**BEFORE THE HEARINGS PANEL
FOR THE QUEENSTOWN LAKES PROPOSED DISTRICT PLAN**

IN THE MATTER of Stage 3b of the
Proposed District Plan

**SECOND REBUTTAL EVIDENCE OF HELEN JULIET MELLSOP
ON BEHALF OF QUEENSTOWN LAKES DISTRICT COUNCIL**

19 June 2020

Figure 1: Map of revised rezoning relief sought by Submitter 31035.

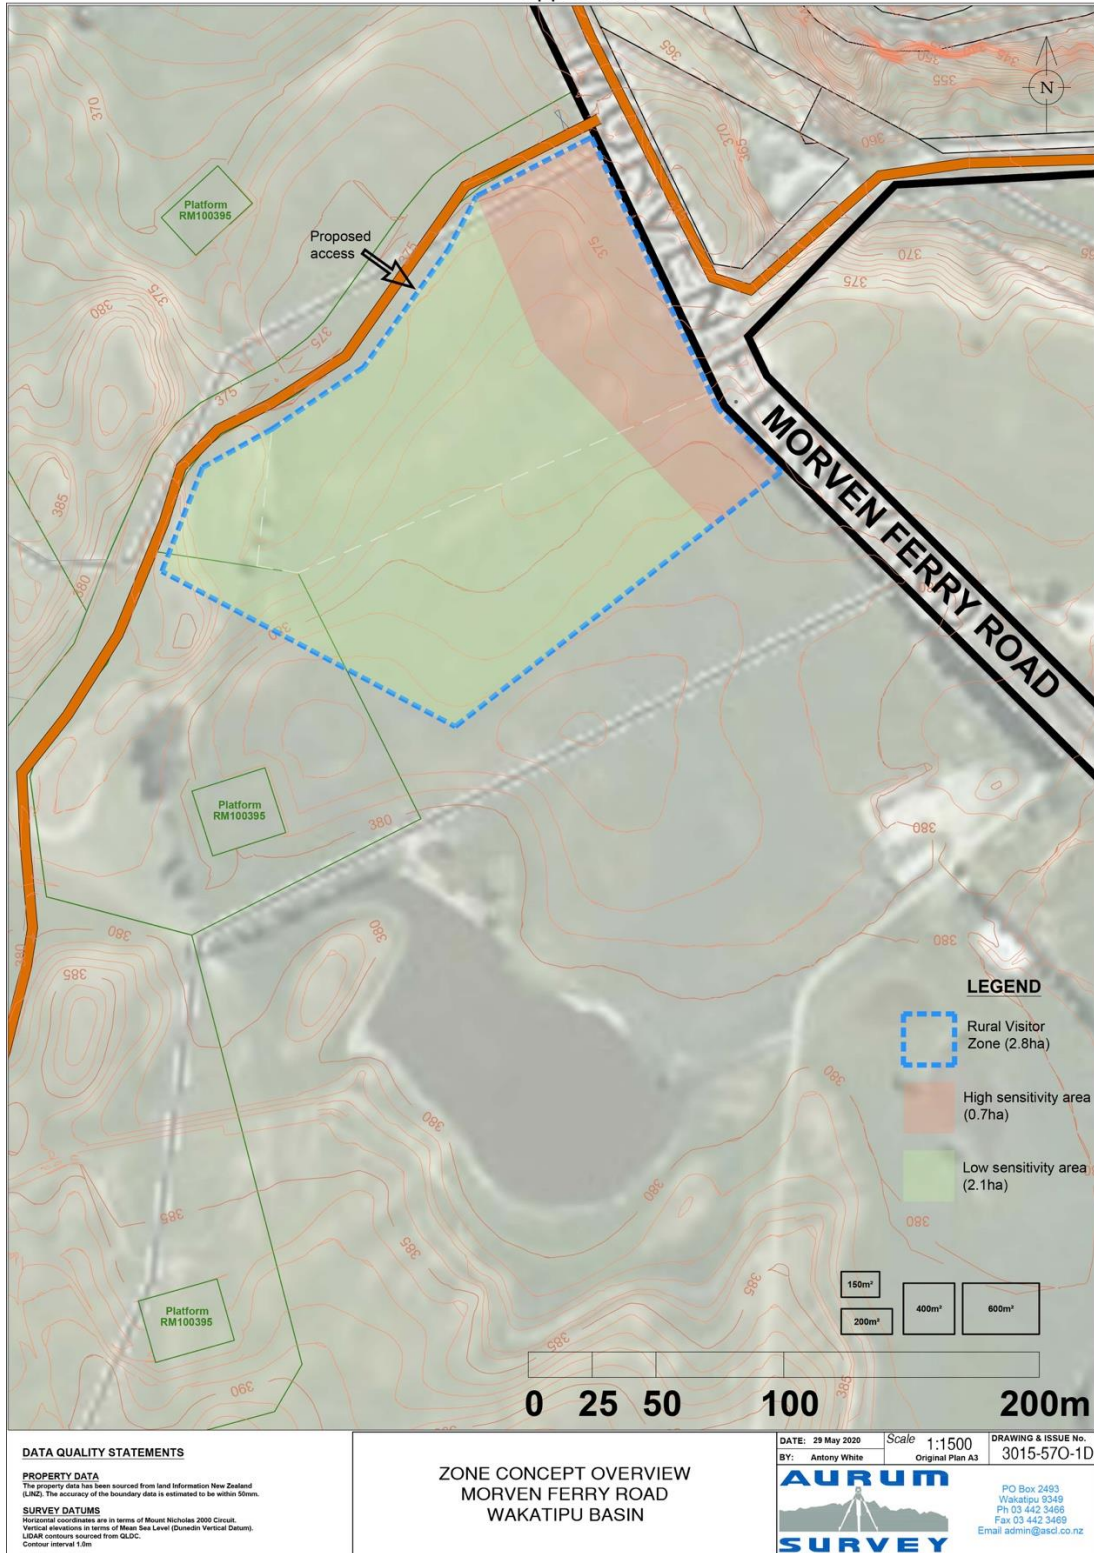
3.3 While the absorption capacity of Landscape Character Unit (LCU) 18 is discussed at paragraphs 5.3 to 5.8 of Mr Espie's Stage 2 evidence, and the previously proposed RVZ (A) is discussed at paragraphs 8.11 to 8.14, this analysis was in the context of the ODP RVZ. The Stage 2 evidence does not include any analysis of the landscape sensitivity of the rezoning site in the context of the PDP RVZ. Nor does it provide any support for the area of High Landscape Sensitivity identified in **Figure 1**. No evidence has been provided to show that the remaining area of the revised RVZ proposal (identified green in **Figure 1**) has a lower level of landscape sensitivity.
